HISTORIC AND DESIGN REVIEW COMMISSION

April 19, 2017

HDRC CASE NO: 2017-164
COMMON NAME: 226 Newell Ave
ADDRESS: 222 NEWELL
212 NEWELL
LEGAL DESCRIPTION: NCB 6326 BLK D LOT 1 THRU 4, 7 THRU 12 & NW IRR 42.32 FT OF 5
TOTAL: 2.122 AC
ZONING: IDZ, IDZ, UZROW RIO-2
CITY COUNCIL DIST.: 1
APPLICANT: Sarah Weston/Silver Ventures
OWNER: Brewery South LLC
TYPE OF WORK: New construction
REQUEST:

The applicant is requesting a Certificate of Appropriateness for approval to construct a 223 unit apartment structure at 226 Newell Avenue.

Lighting Plan

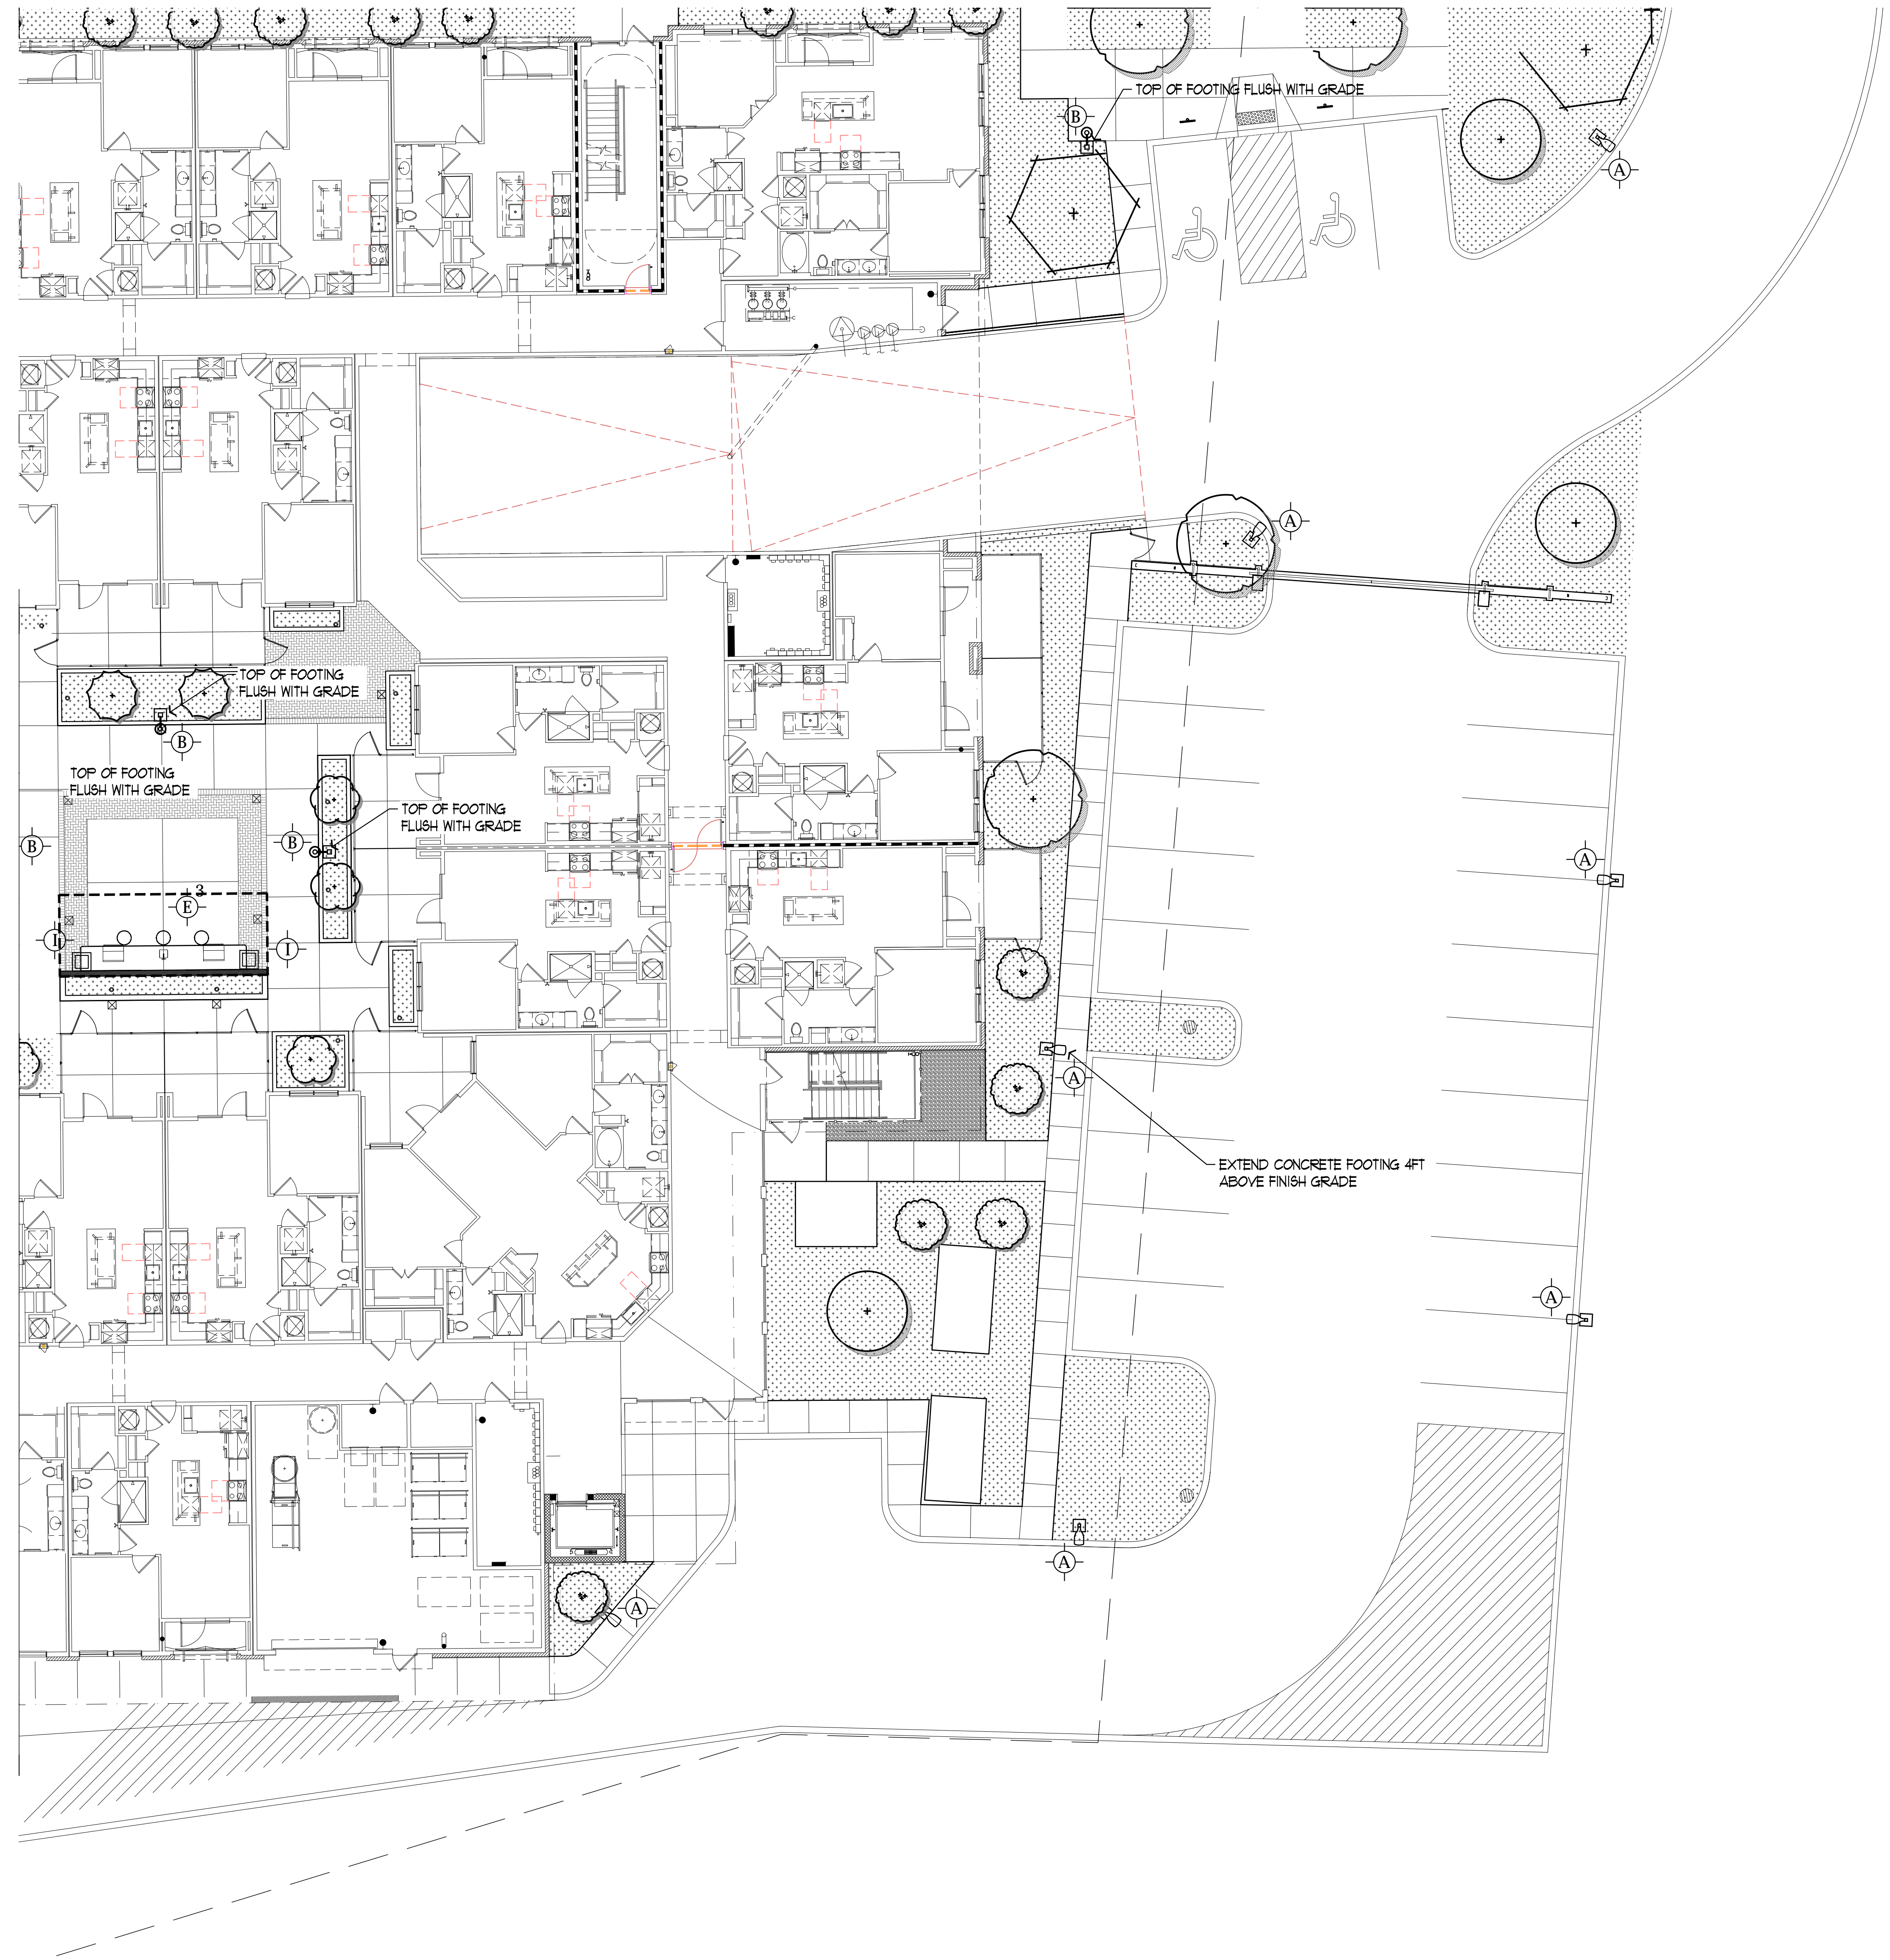
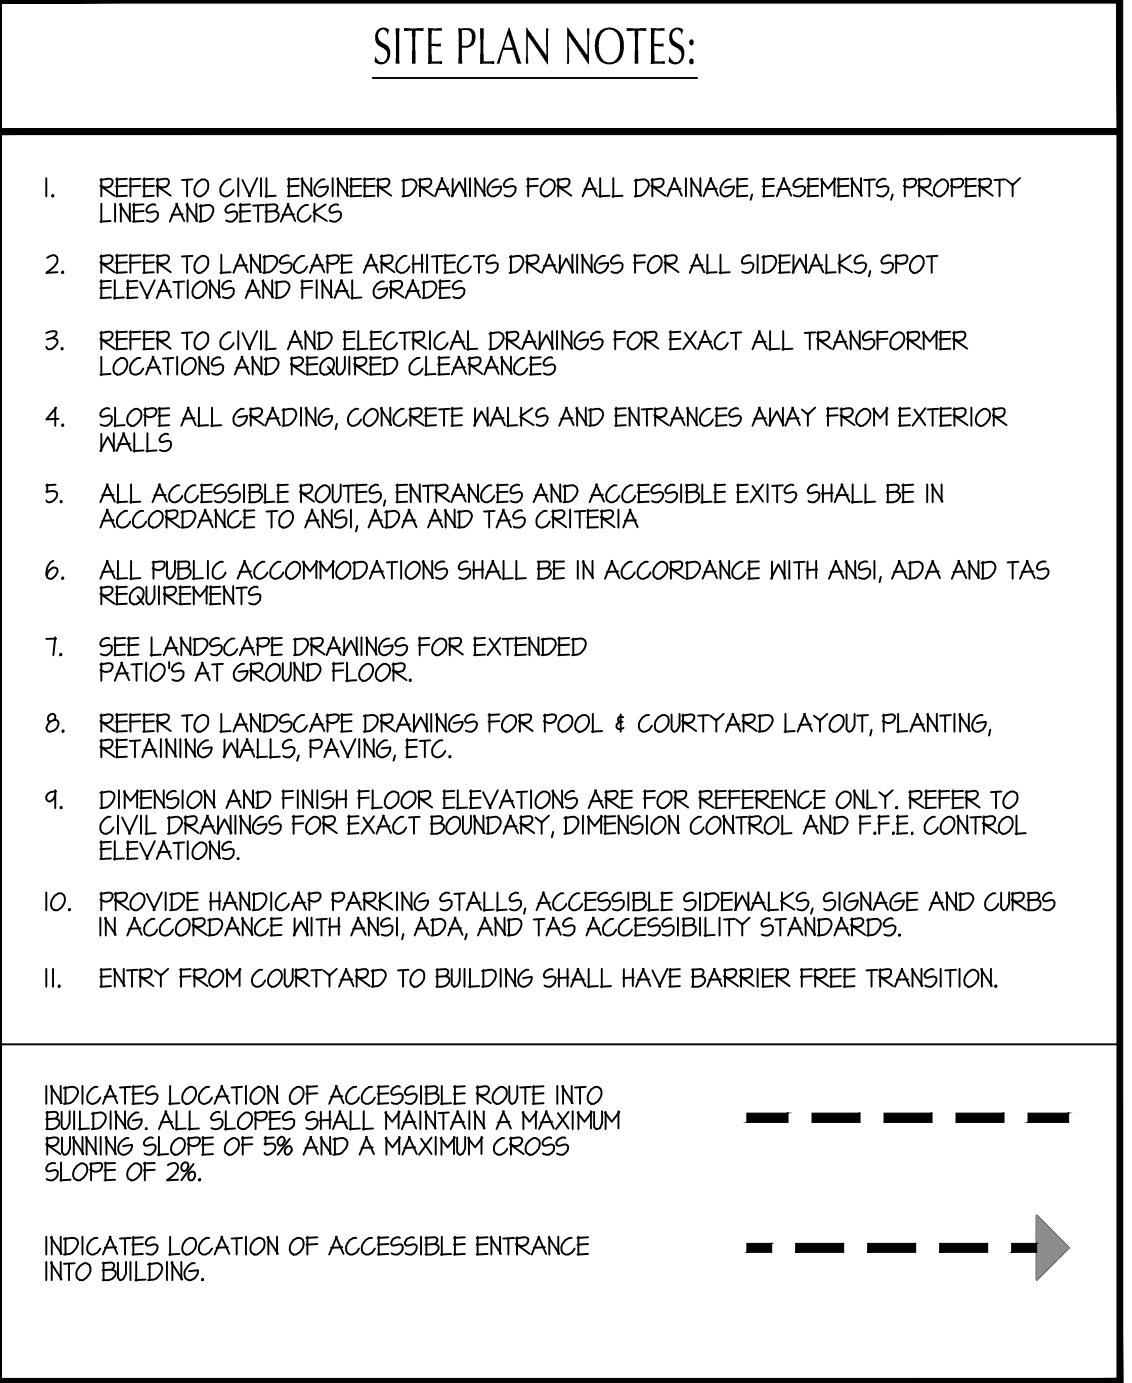
- j. LIGHTING – The applicant has provided a lighting plan noting the location of exterior and site lighting. This is consistent with the UDC Section 35-673(j).

WINDOW HEAD DETAIL @ STUCCO

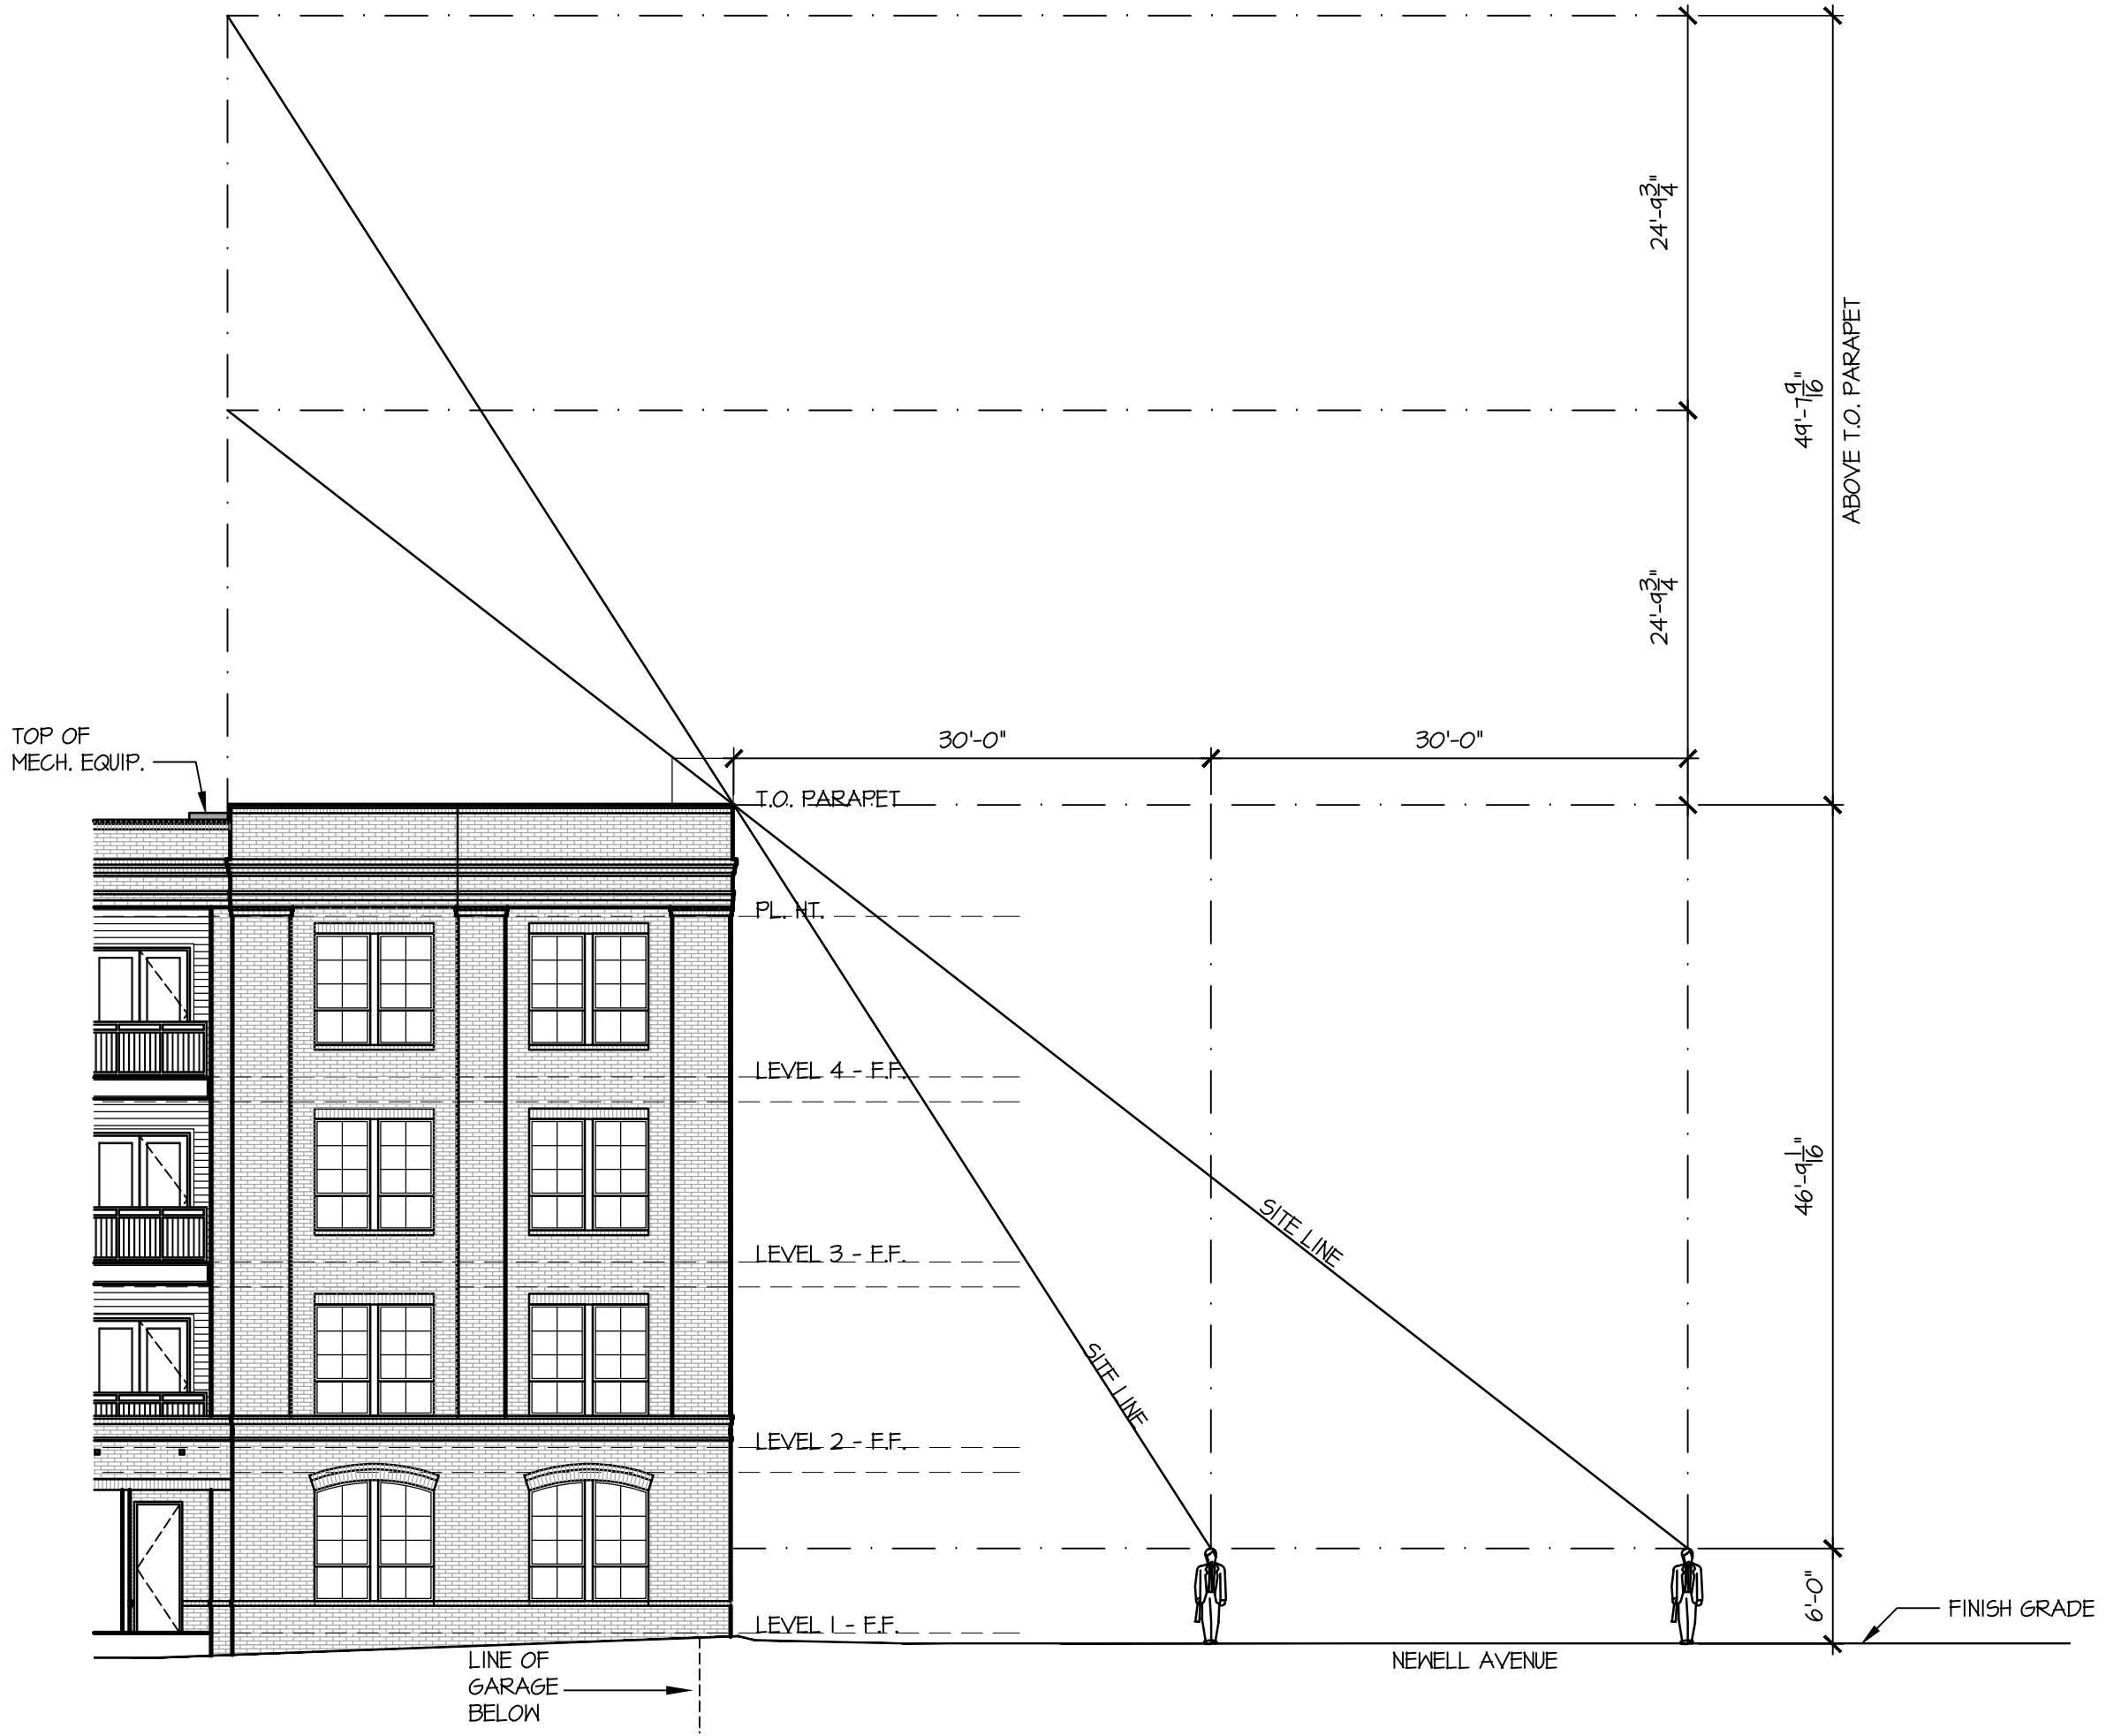
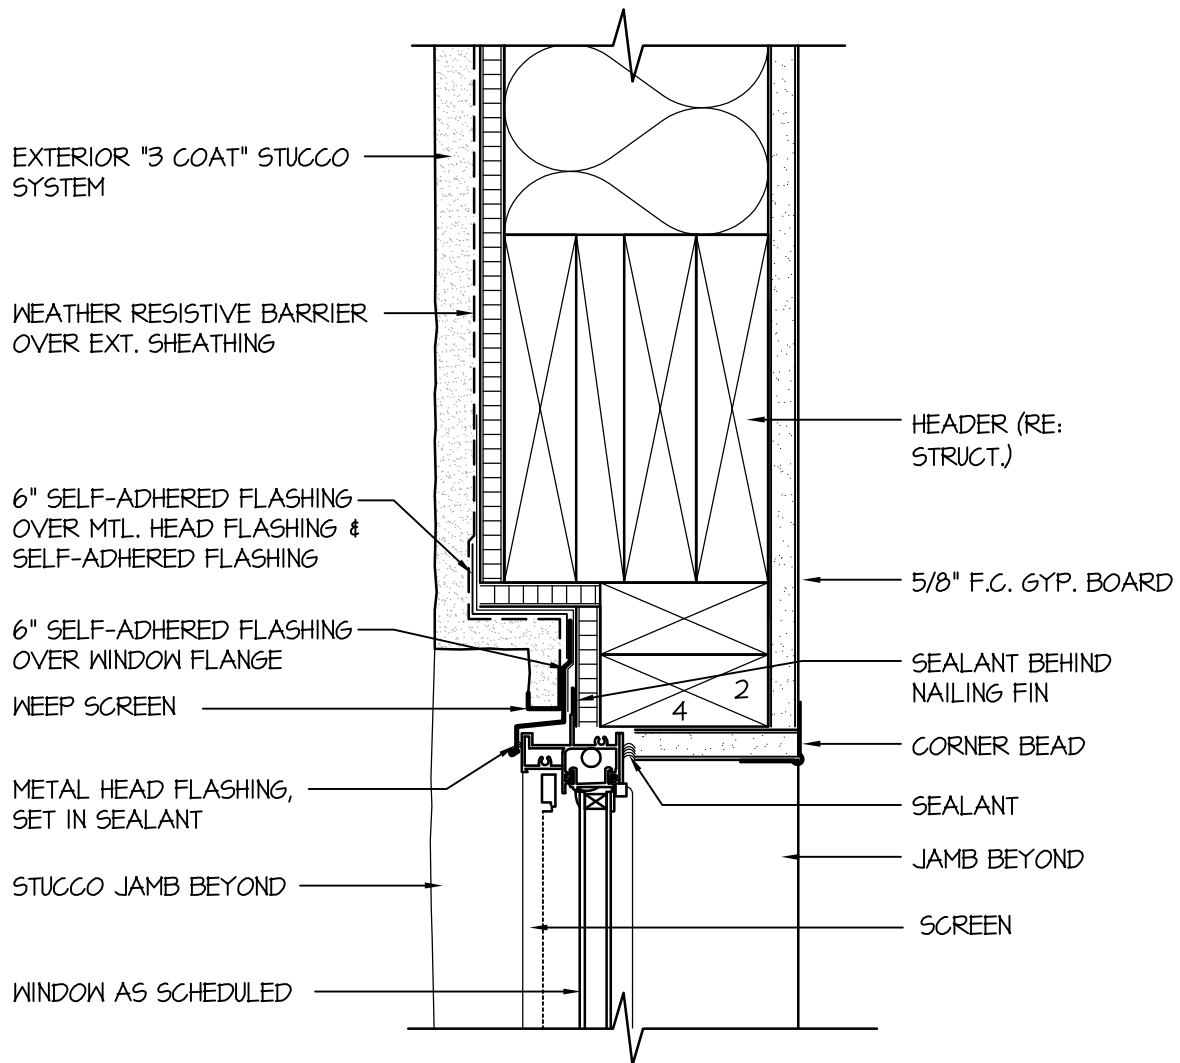
- r. WINDOW FENESTRATION – In regards to window fenestration, the UDC Section 35-674 (2) states that windows help provide a human scale to a façade and therefore should be recessed at least two (2) inches within solid walls, they should relate in design and scale to the spaces behind them, they shall be used in hierarchy to articulate important places on the façade and grouped to establish rhythms and that curtain wall systems should be designed with modulating features such as projecting horizontal and/or vertical mullions. The applicant has provided a detailed wall section noting a recessed framing of at least two (2) inches.
